2nd Further Information

**Proposed Temporary Shop and Services, Eating Place and Public Vehicle Park
(Excluding Container Vehicle) for a Period of 5 Years in “Residential (Group C)” Zone,
Lots 347 S.B (Part), 347 S.D (Part) and 348 (Part) in D.D. 109, Kam Tin, Yuen Long, New Territories**

(S.16 Planning Application No. A/YL-KTS/1088)

Response-to-Comment (RtC)

PROJECT: Proposed Temporary Warehouse (excl. D.G.G.) with Ancillary Facilities and Associate Filling of Land for a Period of 3 Years in “Agriculture” Zone	TITLE PROPOSED DRAINAGE SYSTEM	FIGURE NUMBER FIGURE 3		
		VER	DESCRIPTION	DATE

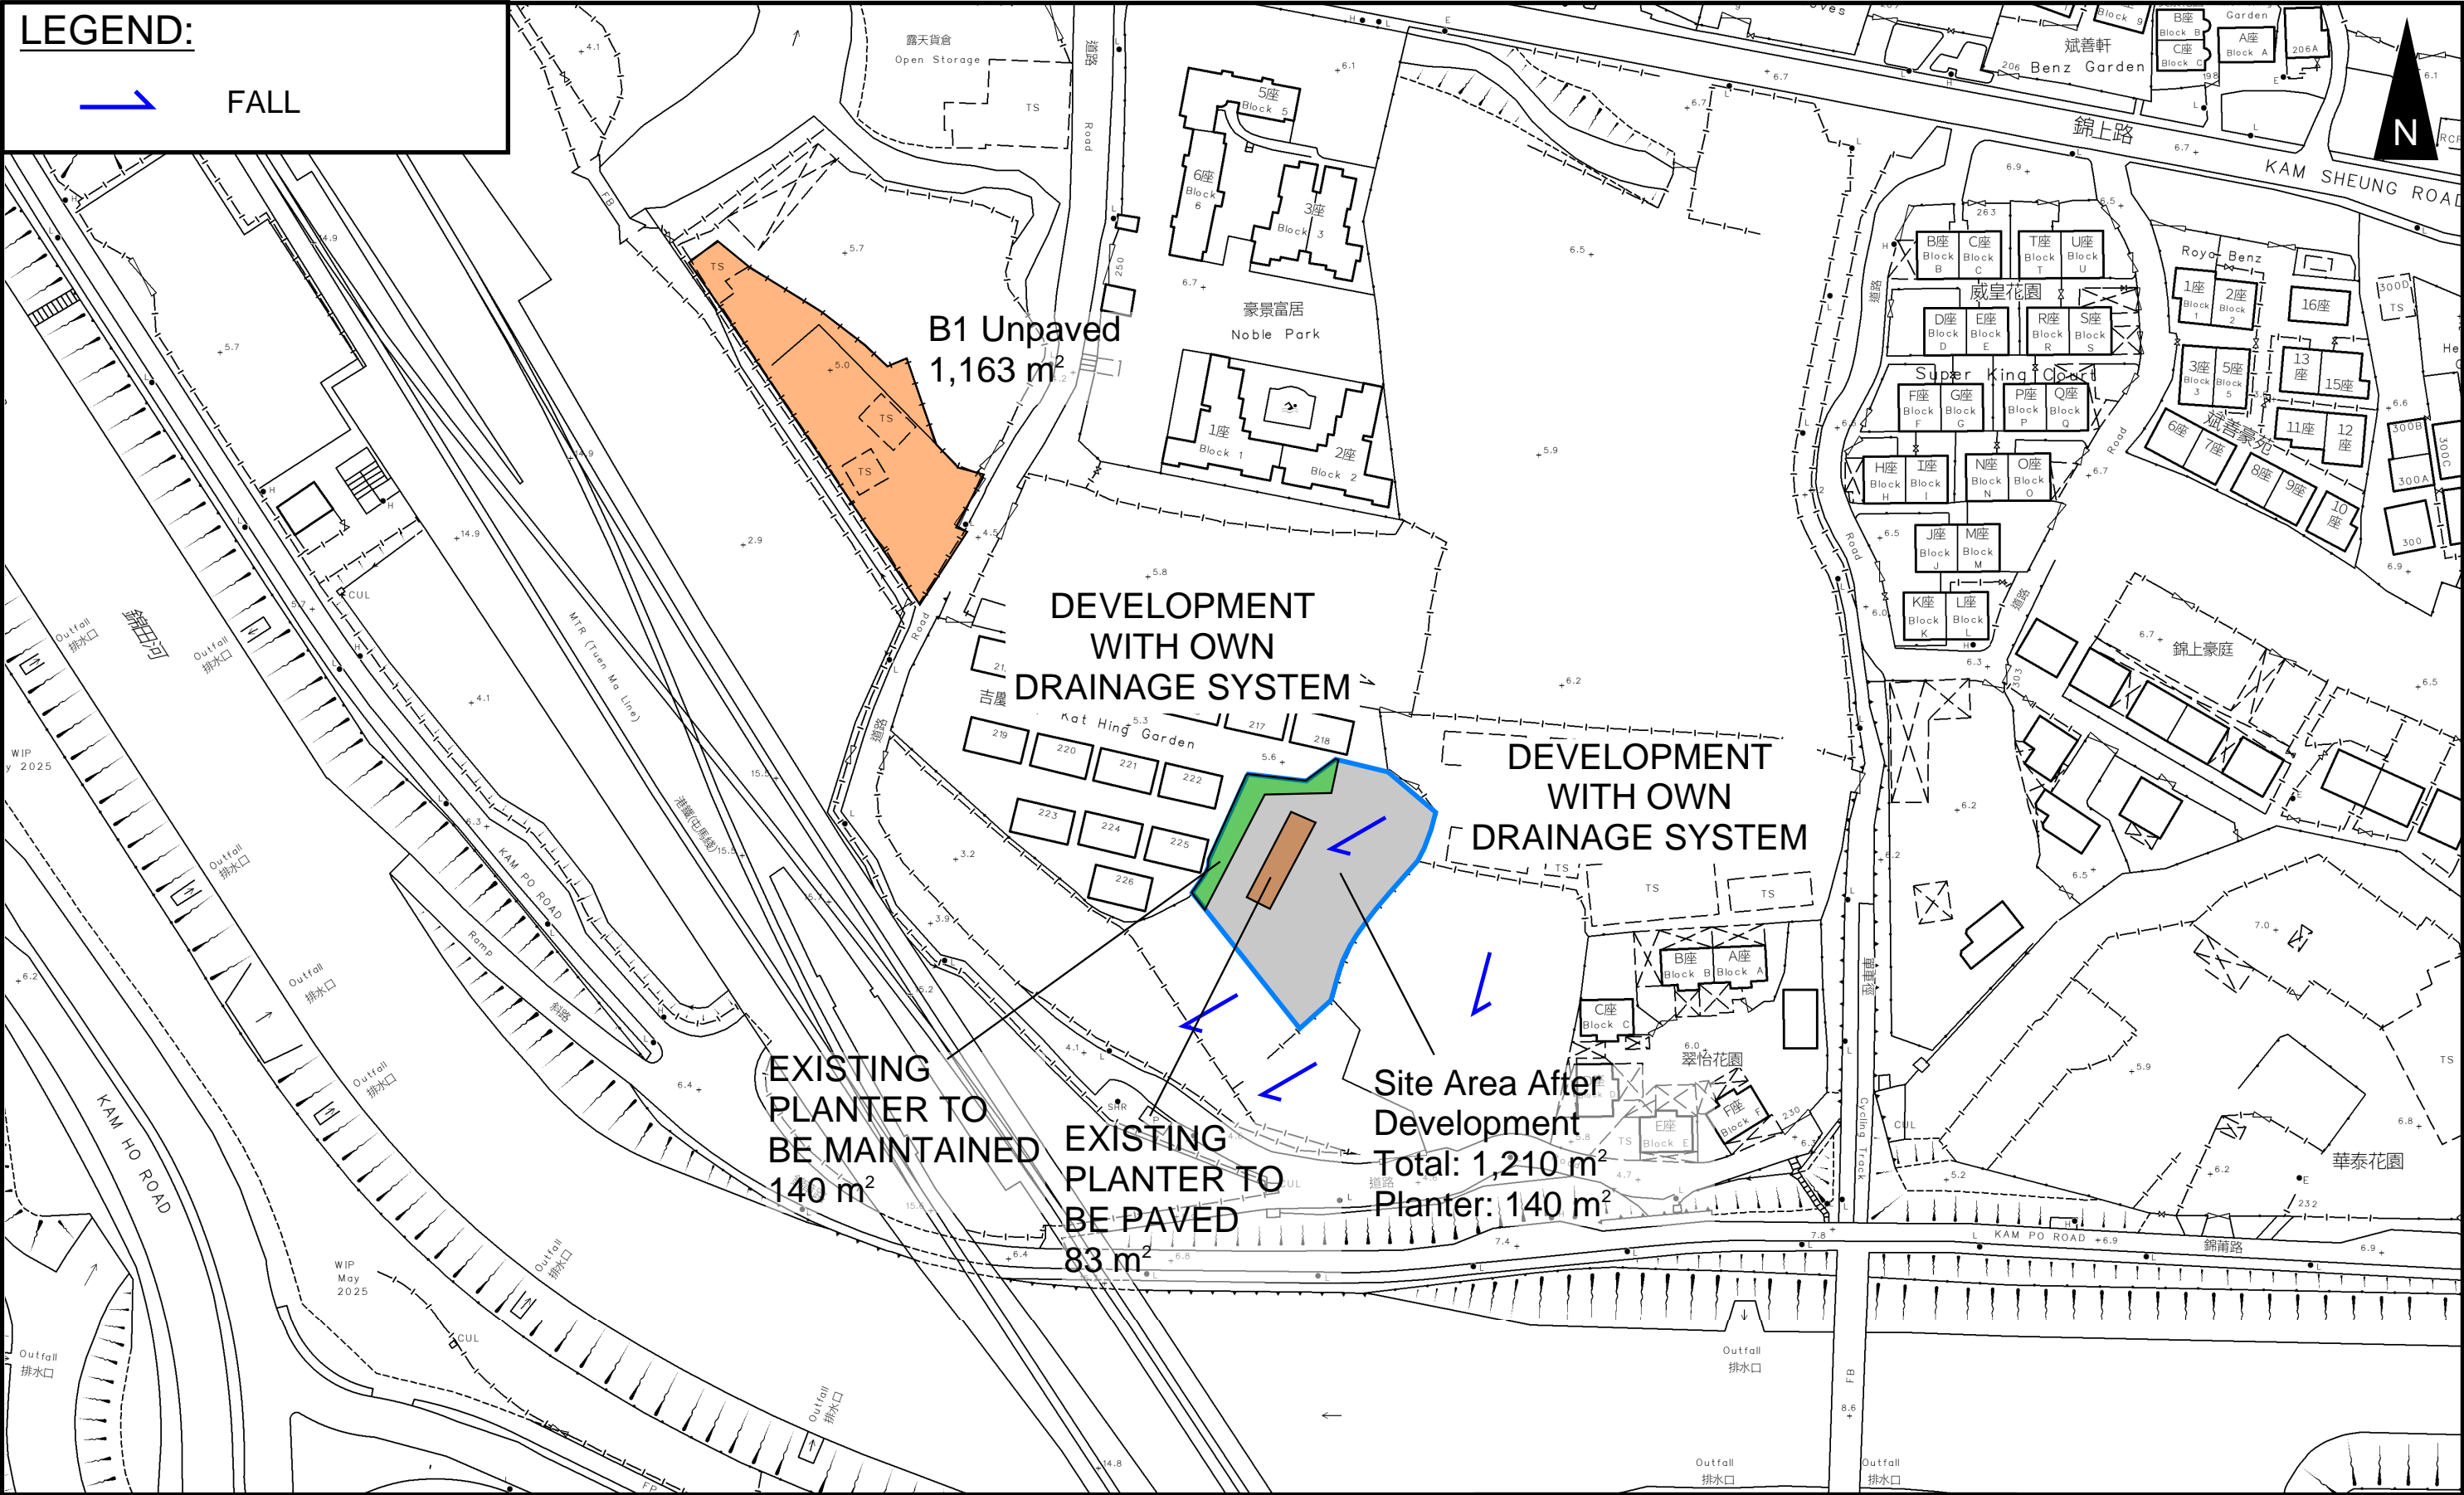
(c)	The size and gradient of the proposed/existing drainage facilities to be discharged from the Site and/or the overland flow intercepted from the adjacent lands should be indicated in the drainage plan. The applicant should check and ensure the hydraulic capacity of the existing drainage facilities would not be adversely affected by the captioned development.

(i)	Please provide hydraulic calculations for the proposed discharging drainage facility

Departmental Comments		Applicant's Responses
2. Comments of the Chief Engineer/Mainland North, Drainage Services Department (CE/MN, DSD)		
(a)	Please refer to DSD's Stormwater Drainage Manual and its corrigenda for preparation of the drainage assessment /proposal.	Noted. Please refer to the enclosed revised drainage proposal at Annex 1 .

N.T.S.
SECTION A-A

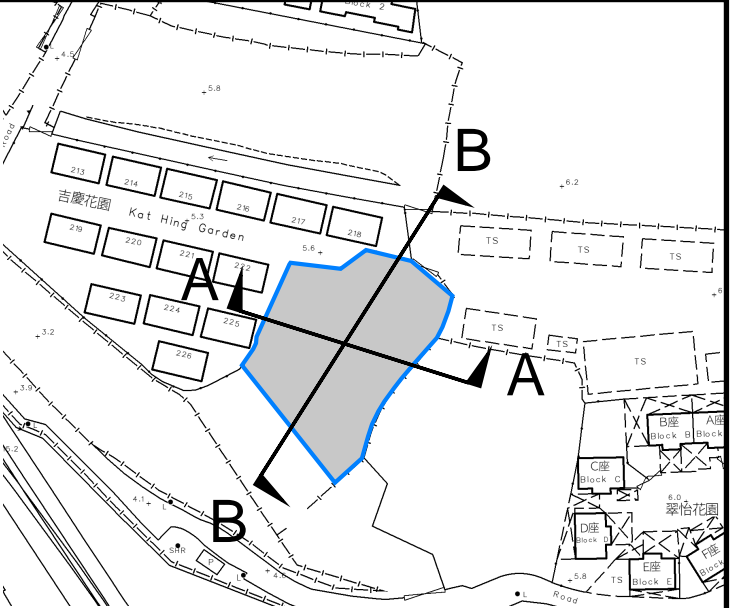
(f)	Cross sections showing the existing and proposed ground levels of the captioned site with respect to the adjacent areas should be given.	
(g)	Standard details should be provided to indicate the sectional details of the proposed u-channel and the catchpit/sand trap.
